## SERVICE BULLETIN NO. OSB1078-174

ATA-Code: 11-30 Internal Placards and Markings  
Marking of the canopy emergency release handle

Fig.

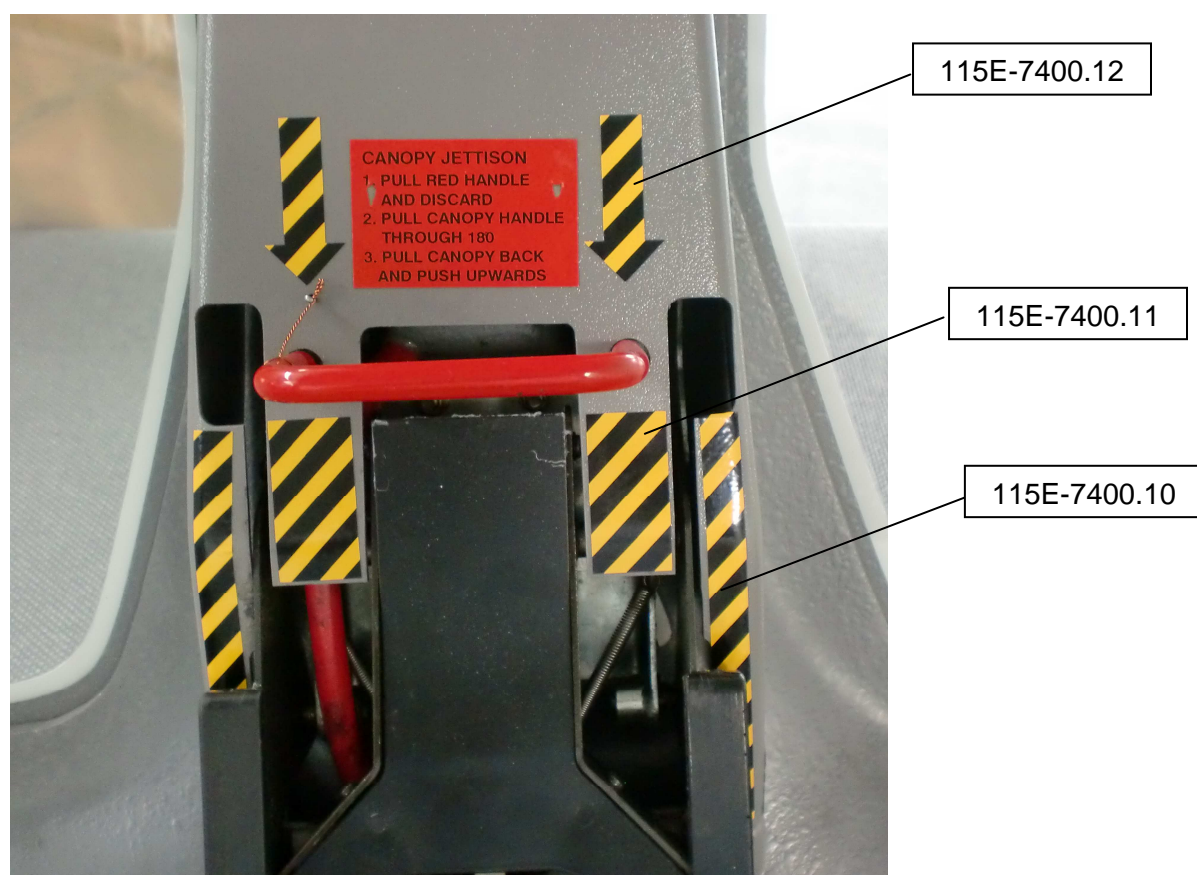
GROB received a customer request to mark the canopy emergency release handle of civil registered aircraft with yellow / black stripes in accordance with military regulations.

This Service Bulletin describes the procedure to optionally install the corresponding markings to the canopy lock covering.

- 1.8.1 Ensure that the aircraft is safe for parking I.A.W. MM chapter 10-10.
- 1.8.2 Open canopy.
- 1.8.3 Apply yellow / black adhesive markings (qty. 2 P/N 115E-7400.10, qty. 2 P/N 115E-7400.11 and qty. 2 P/N 115E-7400.12) as shown in Fig. 1.
- 1.8.4 Release aircraft to service.
